# HOLDOVER

## OAK CREEK SUBDIVISION

The plat illustrates the proposed 69-lot, 19.2± acre subdivision which is located on the East side of Riviere du Chien Road, 850'± South of Lloyd Station Road. The site is served by city water and sewer facilities.

APPLICATION NUMBER Holdover DATE April 1, 2004

## DETAIL SITE PLAN

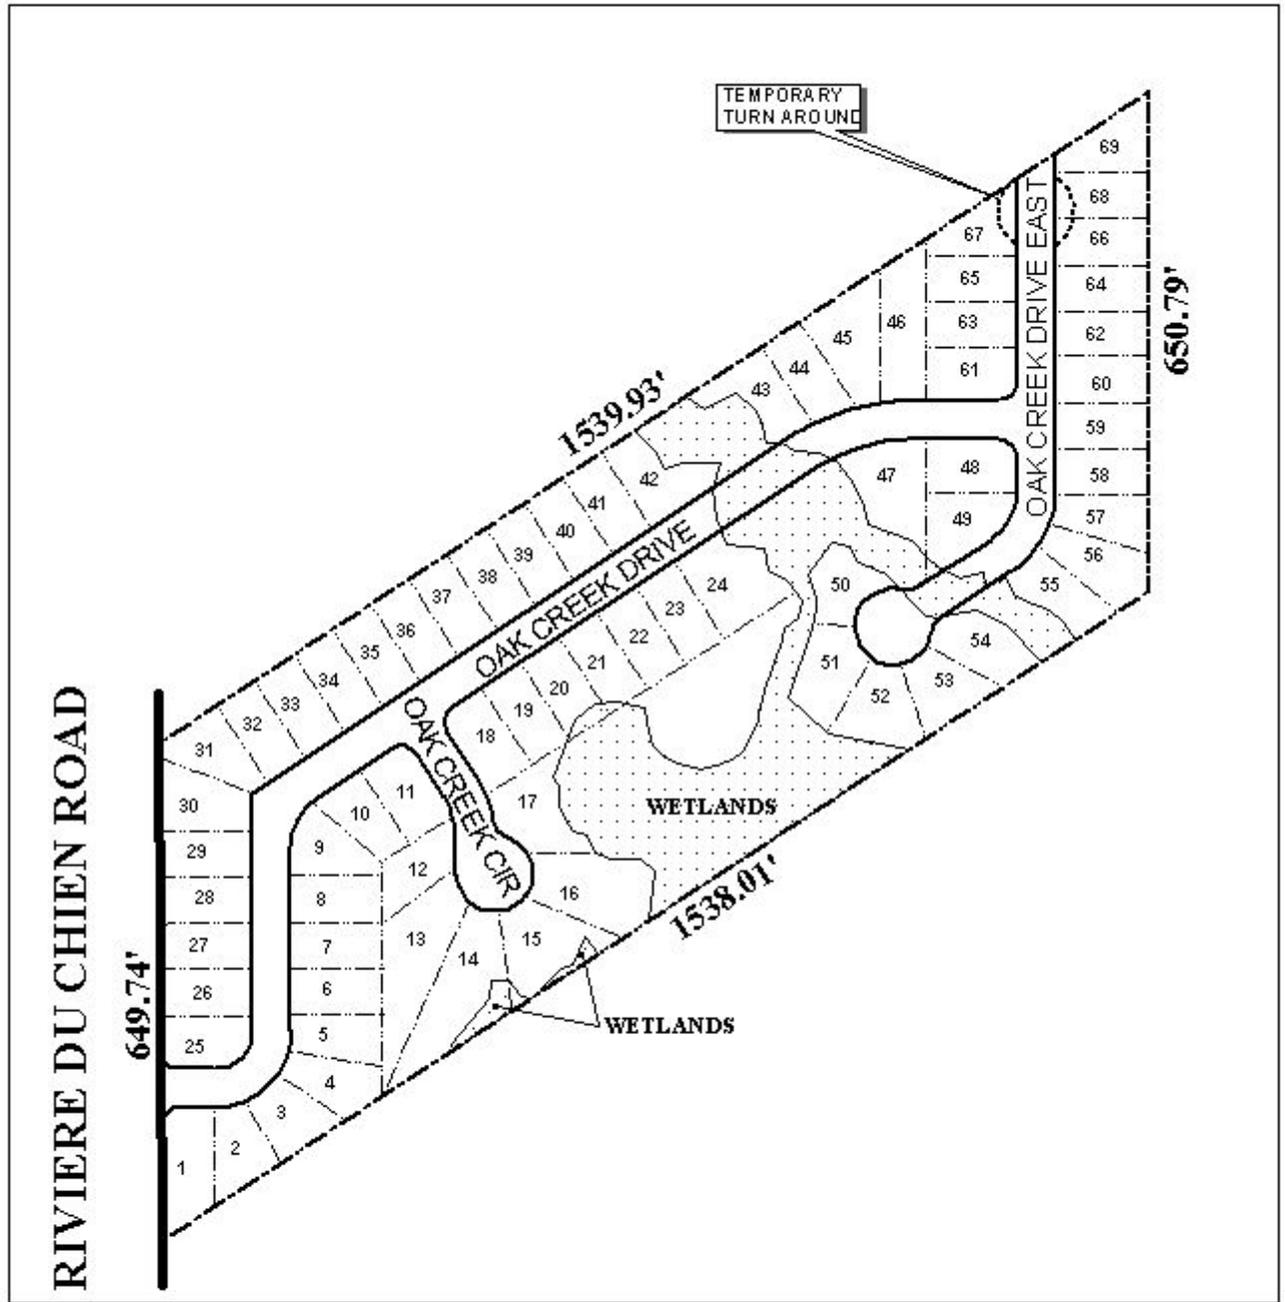
Numerous lots are located on corners and several as proposed would be considered double-frontage lots. Therefore, these lots should be limited to one curb cut to the new subdivision streets; specifically, Lots 1, and 25 thru 31 should be denied direct access to Riviere du Chien, and Lots 11, 18, 48, and 61 should be limited to one curb cut.

On the preliminary plat there is an area labeled as common area; the use of the area should be reflected on the final plat with a note stating that the maintenance thereof shall be the responsibility of the property owners.

As illustrated on the site plan an area designated as wetlands bisects the development; therefore, it could be considered environmentally sensitive and the approval of all applicable federal, state and local agencies would be required.

The 25-foot minimum building setback line is not shown but would be required on the final plat.

With modifications, the plat will meet the minimum requirements of the Subdivision Regulations and is recommended for Tentative Approval subject to the following conditions: 1) the placement of a note on the final stating that Lots 1 and 25 thru 31 are denied direct access to Riviere du Chien; 2) the placement of a note on the final plat stating that Lots 11, 18, 48, and 61 are limited to one curb cut; 3) approval of all applicable federal, state and local agencies; and 4) placement of the required 25-foot minimum building setback line on the final plat.
